**BEFORE HEARING COMMISSIONERS
FOR SELWYN DISTRICT COUNCIL**

IN THE MATTER Private Plan Change Request
69 (PC69)

URBAN DESIGN AND LANDSCAPE HEARING REPORT

**HUGH ANTHONY NICHOLSON
ON BEHALF OF SELWYN DISTRICT COUNCIL**

Figure 2: PC69 Connections

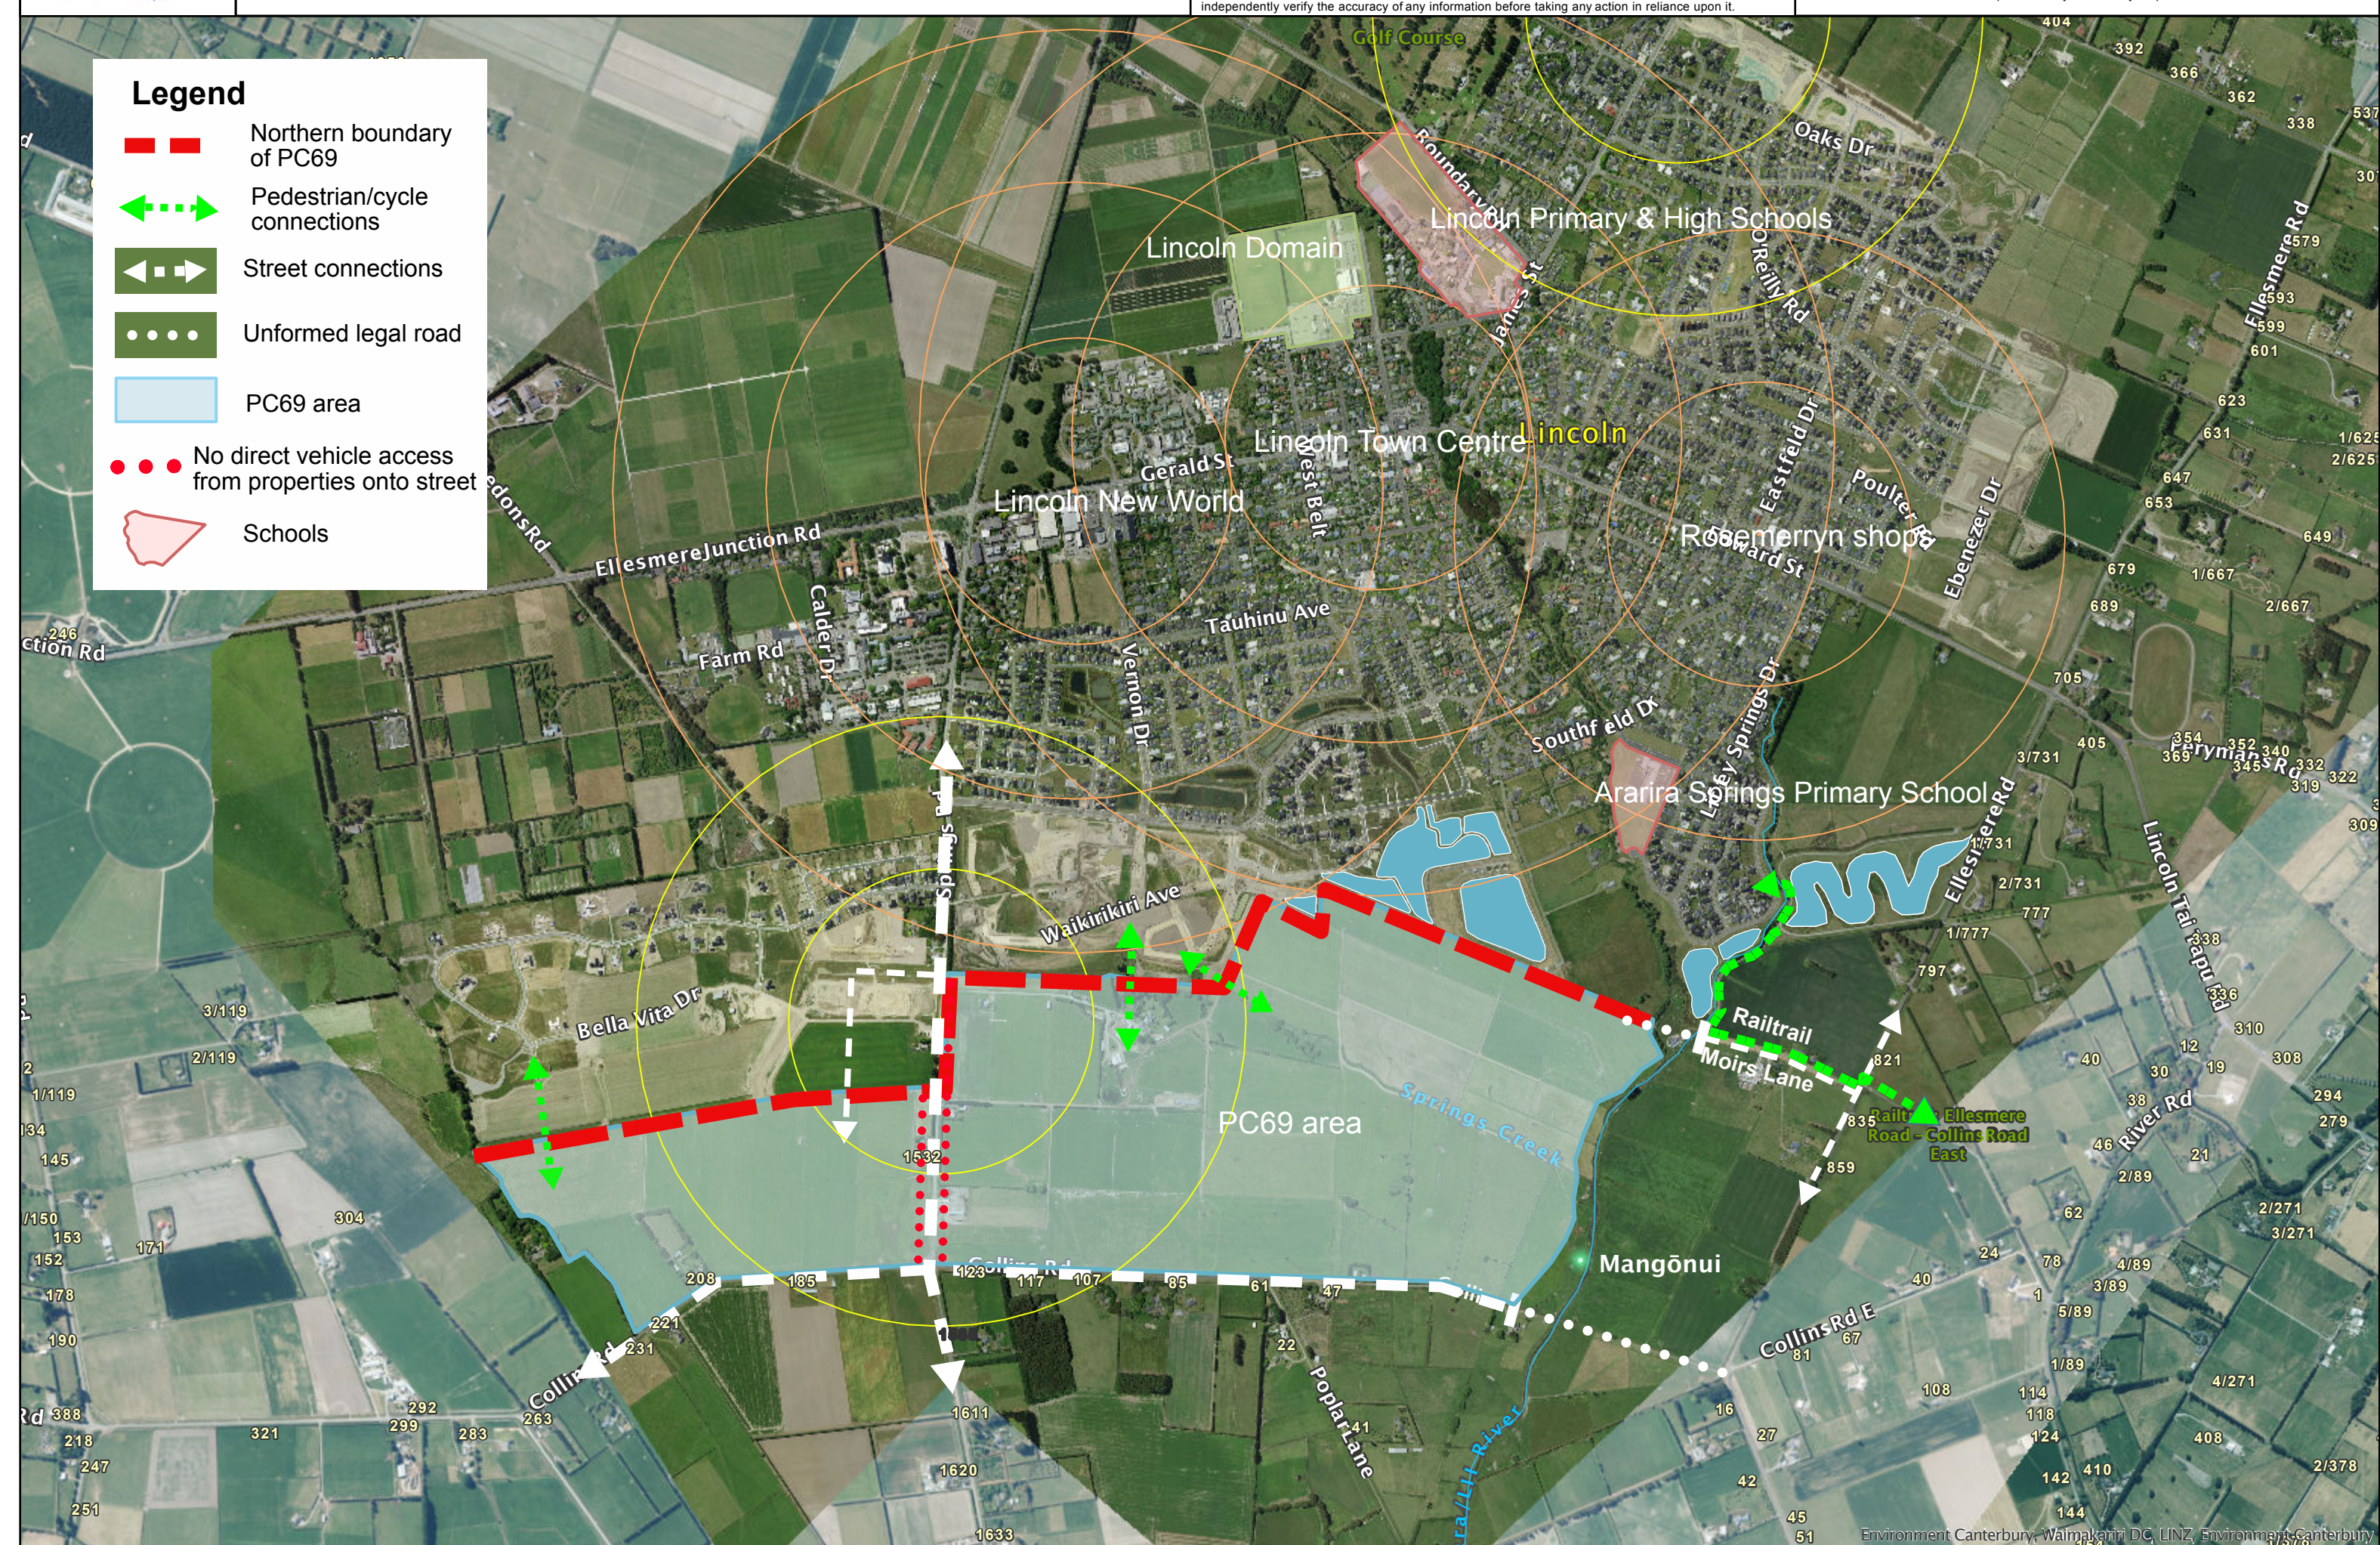
- 10.6 In summary the northern boundary of PC69 with the existing township extends just over three kilometres as the crow flies and includes a single road connection and three green links / cycleway connections with the existing Lincoln township. Much of the eastern end of the boundary is defined by stormwater and wastewater ponds from subdivisions to the north. (see Figure 2)

- 10.11 In my opinion the proposed street network in the ODP for the PC69 area would have limited connectivity to the existing Lincoln street network with a single direct road connection and three direct pedestrian / cycleway connections . Best practice would suggest that connections should be provided within walkable distances along the boundary without requiring pedestrians to double-back, or spaced at 400 metre intervals.
